# UNITED STATES PATENT AND TRADEMARK OFFICE

10/519,279

<b>Office Action Summary</b>	<b>Application No.</b> 10/519,279	<b>Applicant(s)</b> RODDIS, ALAN JAMES	
	<b>Examiner</b> Vishal Patel	<b>Art Unit</b> 3676

## **DETAILED ACTION**

Fig. 2

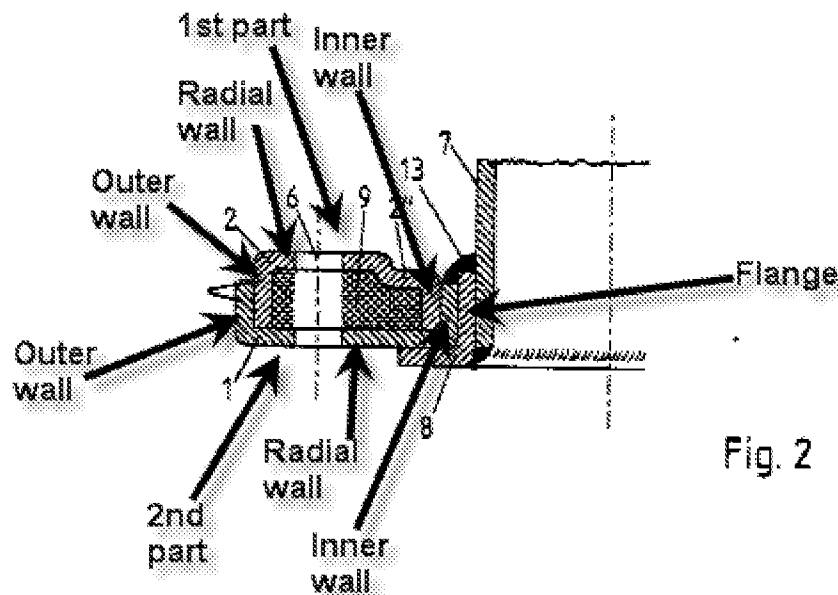
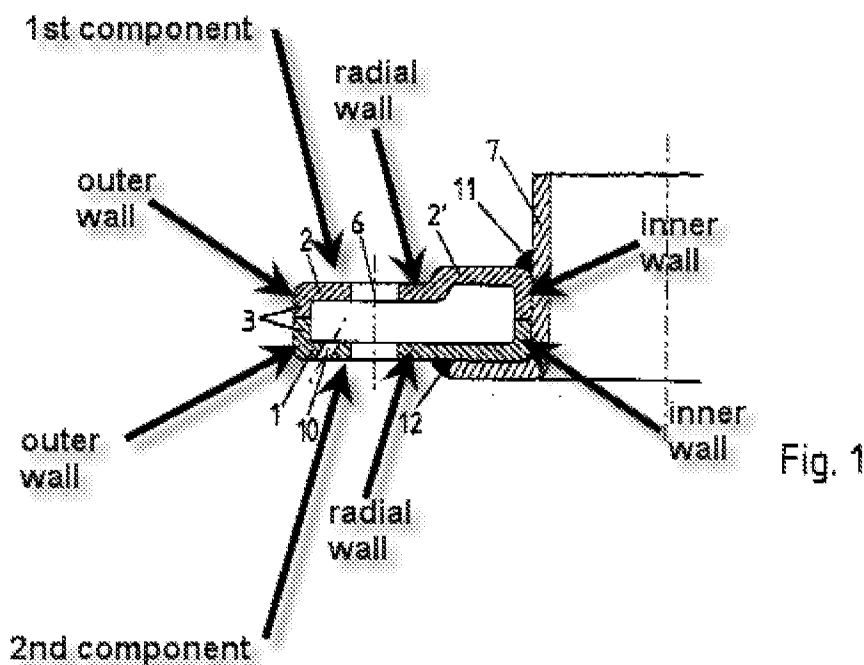
Kirchkamp discloses a mechanical seal (figure 2) having a gland plate (e.g. plate formed by 1, 2 and 9 attached to form a seal on 7). The gland plate has structure claimed by applicant in claims 1, 4-7, 10-12 and 14-15.

Kirchkamp further discloses the gland plate comprising a rigid, annular element comprising at least one two axially radially extending walls (e.g. radial wall of 1 and 2 of figure 2) having a thickness, the radially extending walls having a center orifice (e.g. center orifice that receives 8) in the center of the radially extending walls and an outer circumferential perimeter extending around an outer edge of the radially extending walls, an outer wall extending axially and continuously between the radially extending walls and around the outer circumferential perimeter of the radially extending walls (e.g. see above figure), an inner wall extending axially and continuously between the radially extending walls (inner walls of figure above) and around the center orifice, at least one additional orifice (e.g. 6 in the radially extending walls) formed in the at least one two radially extending walls between the center orifice and the outer circumferential perimeter of the radially extending walls. The respective inner circumferential walls and respective outer circumferential walls of the first and second components are brought into juxtaposition and held in engagement to form a hollow, annular structure, the respective

orifices of the first and second components are aligned to form at least one bolt hole (e.g. additional orifice) and the respective circumferential flanges of the first and second components abut (intended use, the first and second component are capable of being juxtaposition). The flanges are defined by the inner walls that form the orifices. The element is filled with concrete, plastic or water (e.g. material of 9).

Regarding the limitations of plastic in claims: Kirchkamp discloses the claimed invention except for the material 9 to be plastic, concrete or water. It would have been obvious to one having ordinary skill in the art at the time the invention was made to have the synthetic material of Kirchkamp to be replaced by plastic or concrete, since it has been held to be within the general skill of a worker in the art to select a known material on the basis of its suitability for the intended use as a matter of obvious design choice. In re Leshin, 125 USPQ 416.
